TECHNICAL INFORMATION

Automatic Temperature Control Fault Display Correction

No: 82/01/03/NAS
Ref:
Issue: 1
Date: 27 February 2004

Range Rover (LP) up to 2A427128

Figure 1

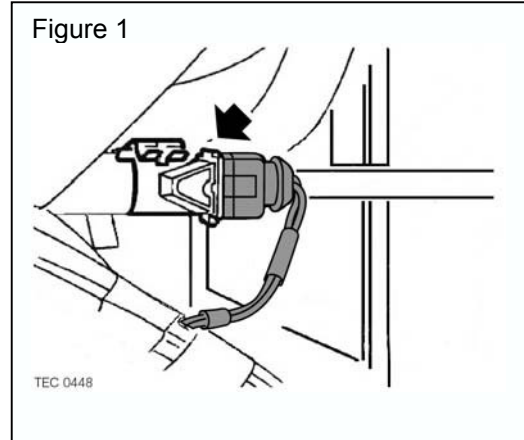
1. Refer to RAVE Workshop Manual section 82.20.94 and perform steps 1-5 to gain access to the heater temperature sensor.
2. Disconnect the heater temperature sensor multi-plug. (Arrowed in Figure 1).
3. Connect the link lead (YMQ501010) to the heater temperature sensor and electrical harness (Figure 2).
4. Reverse the Workshop Manual section 82.20.94 removal procedures steps 1-5, and install the removed components.
